NM 4 THROUGH THE JEMEZ PUEBLO

ROAD SAFETY AUDIT

March 2007

Road Safety Audit
NM4 in the Pueblo of Jemez
Safety Issue 3: Signing, Pavement Markings, and Delineation

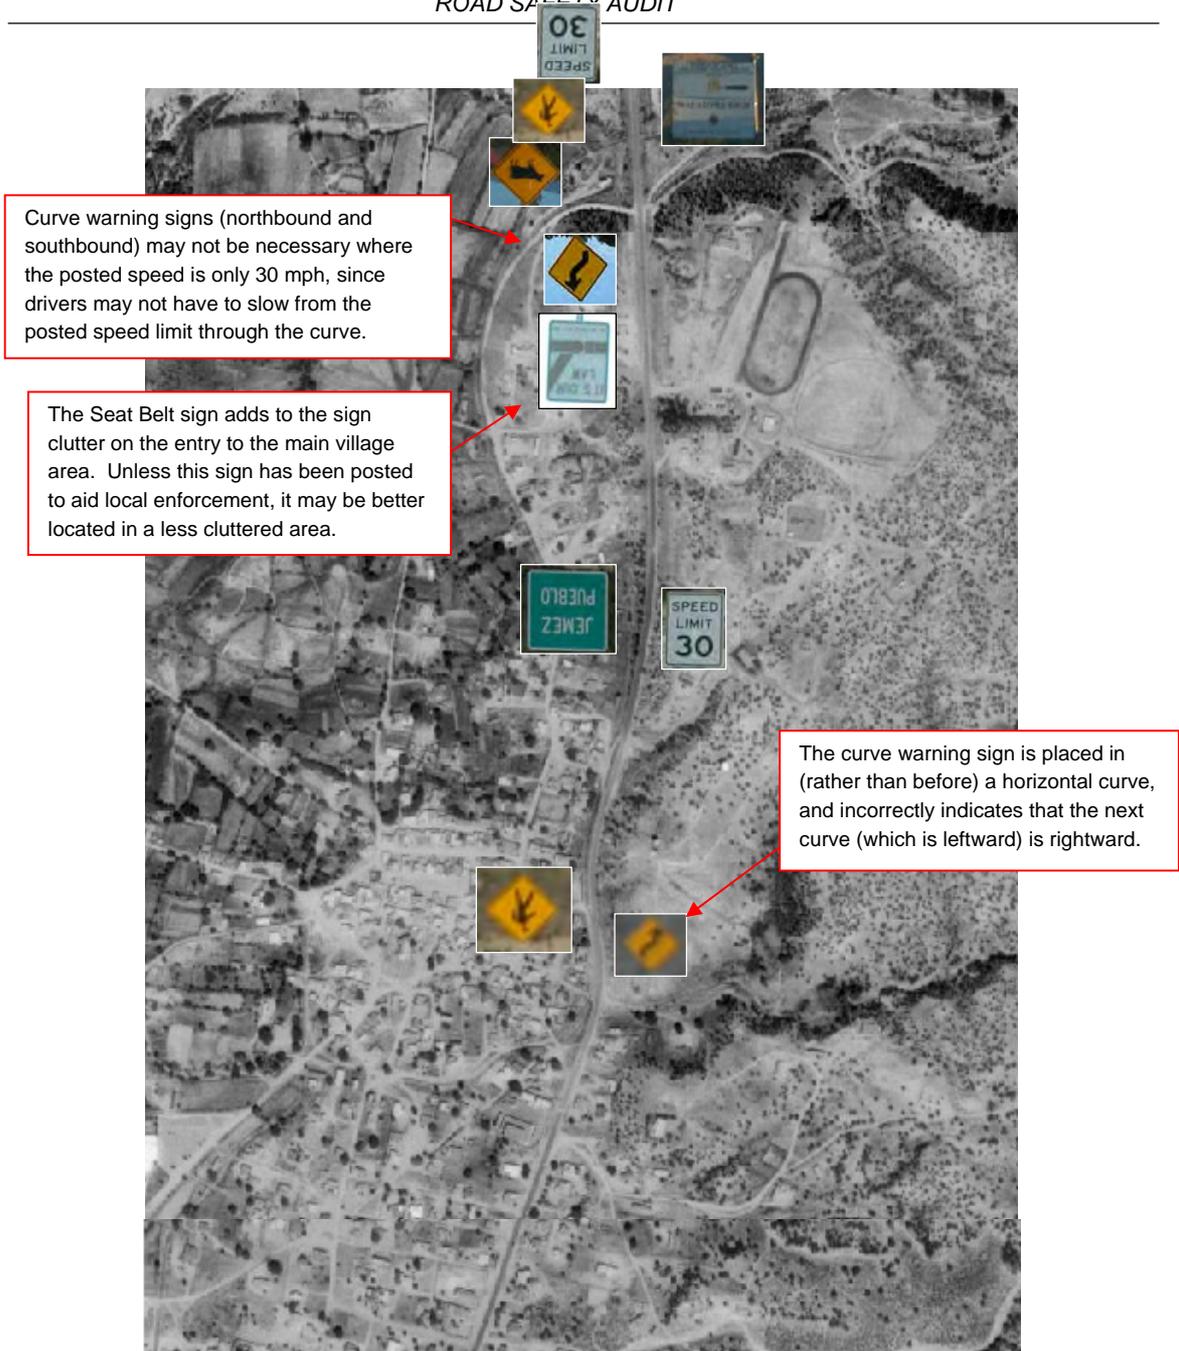
Safety Issue 3: Missing signs, pavement markings, or delineation may limit driver guidance and increase the risk of collision. Excessive signing may distract drivers.

Safety Issue Description: Frequent regulatory, warning, guide, and commercial signs are present along NM4 through the Jemez Pueblo. Signing through the main residential area, summarized in the following two pages, includes 13 road signs (regulatory, warning, and destination) for northbound traffic alone within about 1.8 miles, in addition to frequent commercial signing. The *Manual of Uniform Traffic Control Devices* (<http://mutcd.fhwa.dot.gov/pdfs/2003r1/pdf-index.htm>) advises that regulatory and warning signs should be used conservatively because these signs, if used to excess, tend to lose their effectiveness.

A review of signing (following pages) suggests that signing should be reviewed for:

- *appropriateness:* For example, School signing, which the *Manual of Uniform Traffic Control Devices* (MUTCD) states should be installed in advance of locations where school buildings or grounds are adjacent to the highway, may not be appropriate where it is currently posted along NM4, since there is no school adjacent to the highway. The presence of unwarranted School signing may confuse drivers, and may give a false sense of security to students walking along the highway.
- *correctness:* For example, a curve warning sign posted for northbound traffic incorrectly indicates that a rightward curve where the next curve encountered by drivers is leftward.

Comprehensive Signing Review: A comprehensive signing review may be undertaken along NM4 is suggested to identify:

- signs that are currently missing that should be posted (see Safety Issues 1, 4, and 7) ;
- unnecessary or obsolete signs that should be removed;
- sign maintenance issues (involving damaged/missing signs, signs with poor retroreflectivity, or other maintenance issues).

Improve pavement markings: A chip seal project currently planned as part of NM DOT maintenance activities provides an opportunity to improve pavement markings and curve delineation along NM4.

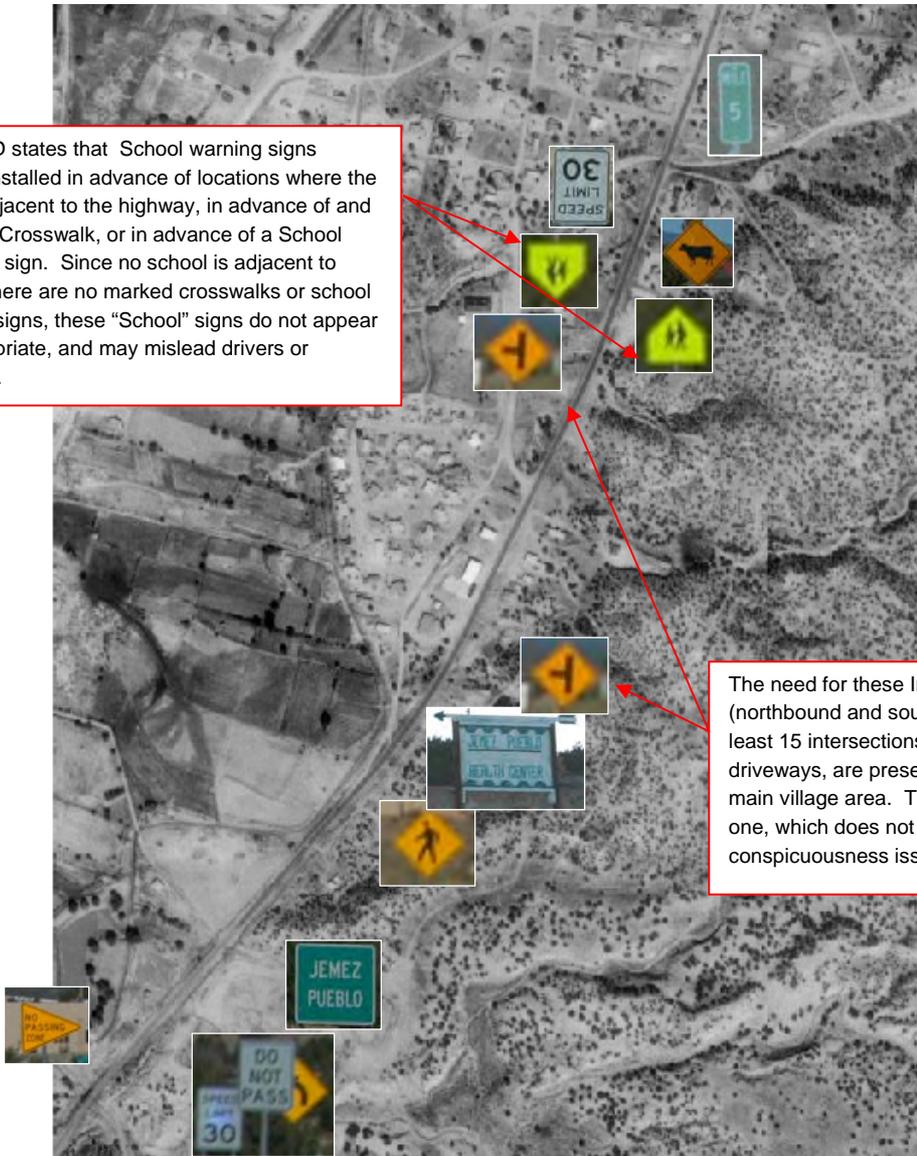
The MUTCD states that School warning signs should be installed in advance of locations where the school is adjacent to the highway, in advance of and at a School Crosswalk, or in advance of a School Speed Limit sign. Since no school is adjacent to NM4, and there are no marked crosswalks or school speed limit signs, these "School" signs do not appear to be appropriate, and may mislead drivers or pedestrians.

The need for these Intersection warning signs (northbound and southbound) may be reviewed. At least 15 intersections, plus numerous private driveways, are present within about 1.8 miles in the main village area. The reason for signing only this one, which does not appear to have visibility or conspicuousness issues, is not clear.
